Access Compliance Report

Public Rights-of-Way

(Curb Ramps)

Intersection ID: 29125	Main Street: ALDERPOINT_LN	Cross Street: APPLEDALE_DR	Location: N
ADA ID: 398CD7EFD280	Ramp Type: PerpDiag	Initial Pass/Fail: Pass	Overall Compliance: No
Severity Score: 17.5			
Codes/Mitigation Info/Possible Solution		Field Measurements/Component Compliance

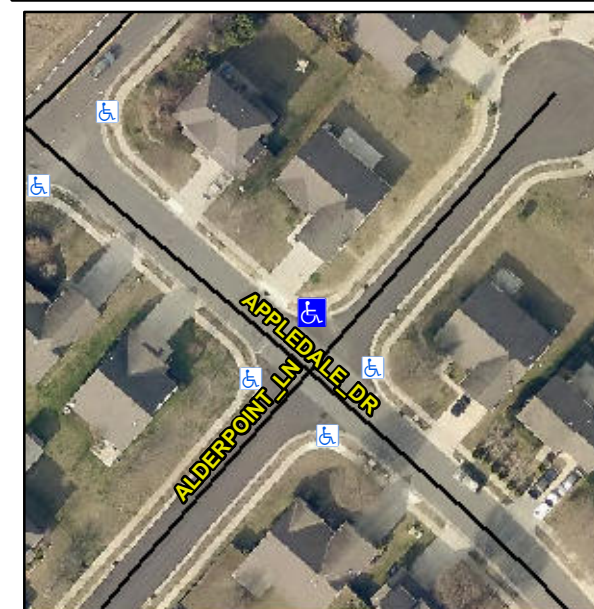
Not Found, R305, R302.7.2, R304.5.3

Compliance	Description	Data	Compliance	Description	Data
N/A	Ramp Length (in)	44.0	Yes	Ramp Slope (%)	8.0
Yes	Ramp Width (in)	123.0	Yes	Ramp XSlope (%)	1.4
N/A	Flare Type LT	Sloped	N/A	Flare Type RT	N/A
N/A	Flare Slope LT (%)	1.3	Yes	Flare Slope RT (%)	2.0
N/A	Flare Traversable LT?	Yes	N/A	Flare Traversable RT?	Yes
Yes	Landing Length (in)	48.0	No	DWS Provided?	No
Yes	Landing Width (in)	123.0	N/A	DWS Contrast?	No
Yes	Landing Slope (%)	1.0	N/A	DWS Length (in)	N/A
Yes	Landing X Slope (%)	0.8	N/A	DWS Full Width?	No
N/A	Landing Curb? (Y/N)	No	N/A	DWS Offset (in)	N/A
N/A	Shared Landing?	No			
Yes	Gutter Ponding?	No	Yes	Gutter Slope (%)	3.3
No	Gutter Lip Ht (in)	0.5	No	Gutter X Slope (%)	2.3
N/A	Painted X Walk1?	No	N/A	Painted X Walk2?	No
	X Walk 1 Direction	To SW		X Walk 2 Direction	To SE
N/A	X Walk 1 Width (in)	N/A	N/A	X Walk 2 Width (in)	N/A
	X Walk 1 Slope (%)	2.4		X Walk 2 Slope (%)	2.6
	X Walk 1 X Slope (%)	0.6		X Walk 2 X Slope (%)	0.6

N/A	Ramp inside XWalk1?	N/A	N/A	Ramp inside XWalk2?	N/A
	Road Slope (%)	1.2	N/A	Clear Space?	Yes
	Road X Slope (%)	1.4	N/A	Clear Space to XWalk (in)	N/A
Yes	Any Obstructions?	No	Yes	Storm Grate/Utility Hazard?	No
	Obstruction Type			Storm Grate/Utility Type	
		N/A			N/A
			Yes	Surface Condition? (G/P)	Good

Remove & Replace Curb Ramp With Two New Directional Ramps or Equivalent. Remove & Replace Gutter.
